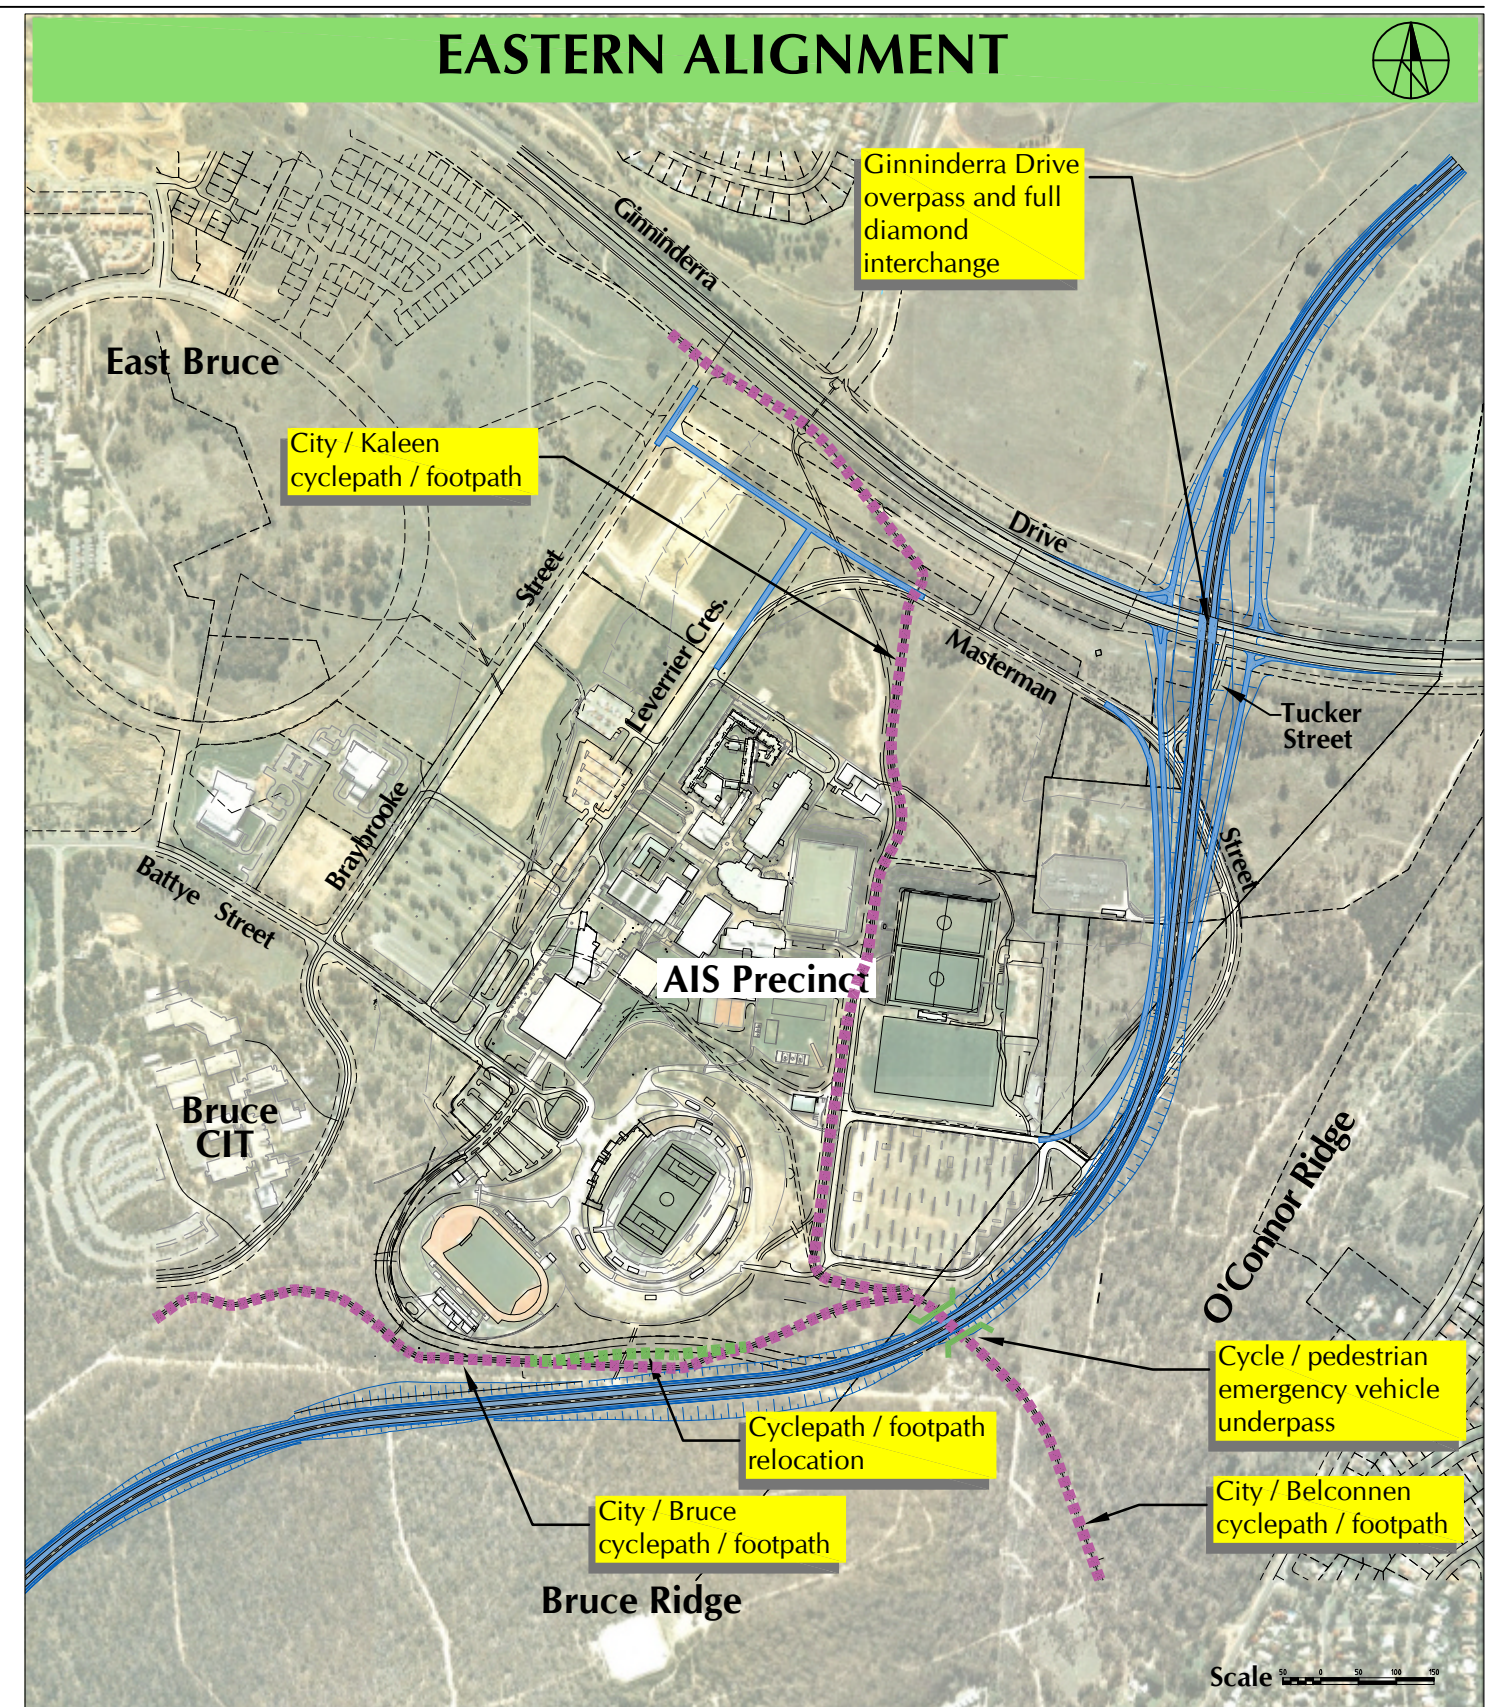
1. Three road overbridges and one cyclepath / footpath overbridge required.
2. Cyclepath / footpath relocation at Ginninderra Drive and Bruce CIT required.
3. Cyclepath / footpaths deviation (400m) at Bruce CIT is about 200m longer than existing and requires an extra 10m of elevation to be traversed

1. One road overbridge and one cyclepath / footpath / emergency services underpass.
2. Relocation of 200m of section of City / Bruce cyclepath / footpath required.
